Amdt to the OL...consist of changes to the tech specs....concerning heatup & cooldown limitations.....

PLANT NAME: **H.B. Robinson**

50-261

H. B. ROBINSON UNIT NO. 2  
LICENSE DPR-23  
REQUEST FOR LICENSE AMENDMENT  
REVISION OF TECHNICAL SPECIFICATIONS

Figure 3.1-1

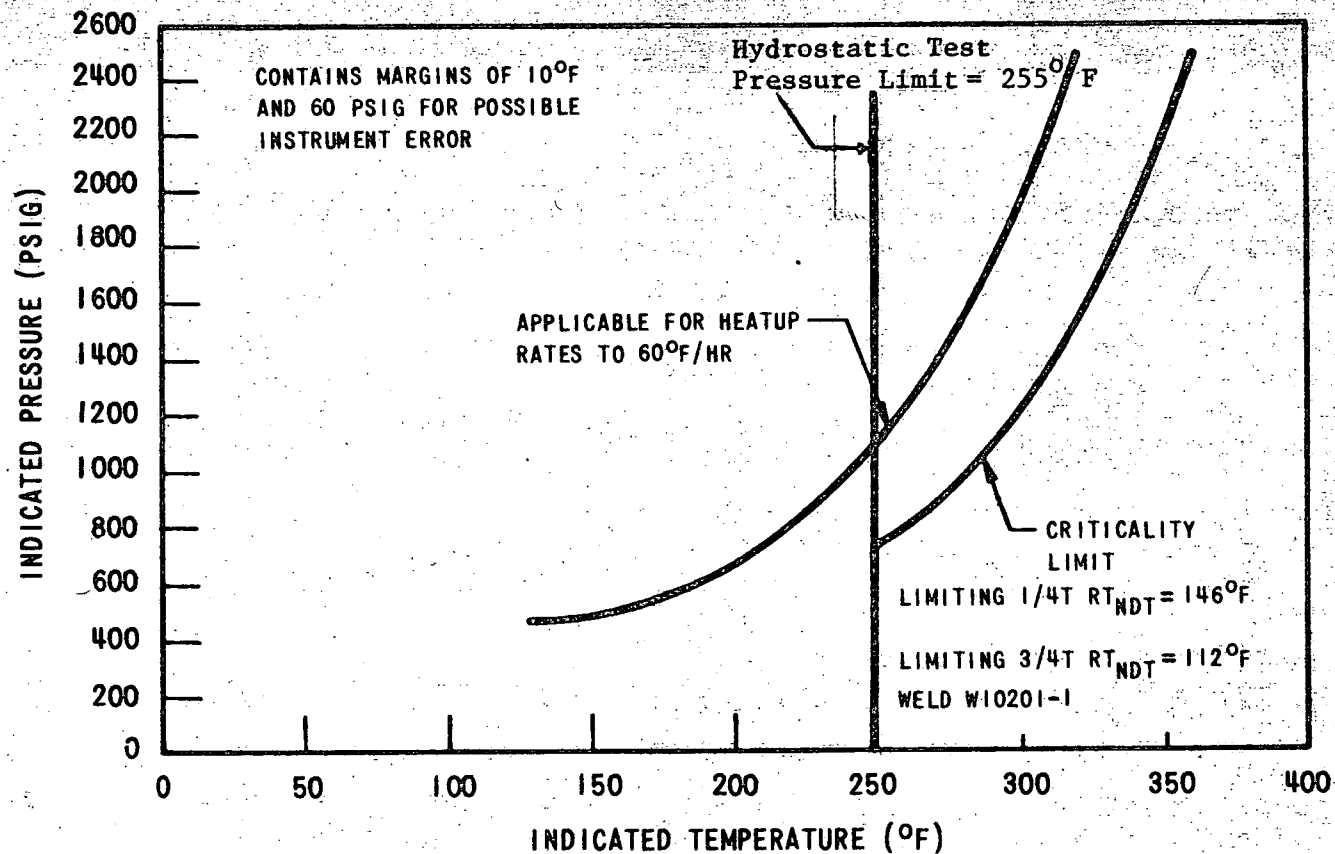
3.1.2.1 The reactor coolant pressure and the system heatup and cooldown rates (with the exception of the pressurizer) shall be limited in accordance with Figure 3.1-1 and Figure 3.1-2, and are as follows:

- a. Over the temperature range from cold shutdown to hot operating conditions, the heatup rate shall not exceed 60°F/hr.
- b. Allowable combinations of pressure and temperature for a specific cooldown rate are below and to the right of the limit lines for that rate as shown on Figure 3.1-2. This rate shall not exceed 100°F/hr. The limit lines for cooling rates between those shown in Figure 3.1-2 may be obtained by interpolation.
- c. Primary System Hydrostatic leak tests may be performed as necessary, provided the temperature-pressure limitations as noted on Figure 3.1-1 are not exceeded. Maximum hydrostatic test pressure should remain below 2350 psia.

The heatup curve of Figure 3.1-1 includes criticality limits which are required by 10 CFR Part 50 Appendix B paragraph IV.A.2.c. Whenever the core is critical, additional safety margins above those specified by the ASME Code Appendix G methods, are imposed. The core may be critical at temperatures equal to or above the minimum temperature for the inservice hydrostatic pressure tests as calculated by ASME Code Appendix G methods, and an additional safety margin of 40°F must be maintained above the applicable heatup curve at all times.

Figure 3.1-3

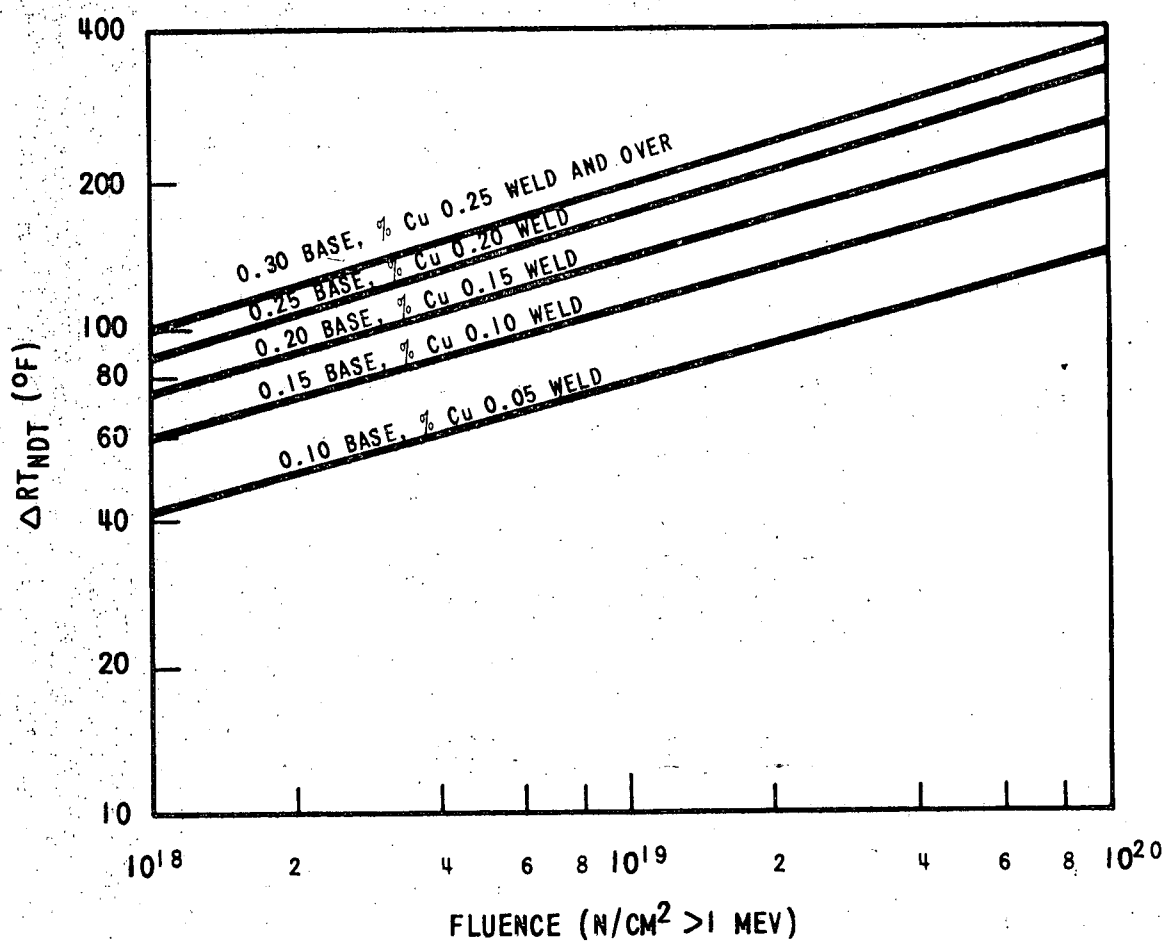
- a. Figure 3.1-3, which shows the effects of neutron fluence and copper content on the shift of  $RT_{NDT}$  due to exposure at 550°F, shall be used to predict the increase in the reference nil-ductility temperature based on the expected vessel exposure. If measurements on the irradiation specimens show increases above and to the left of the predicted curve, a new curve shall be constructed such that it encompasses the applicable data points.
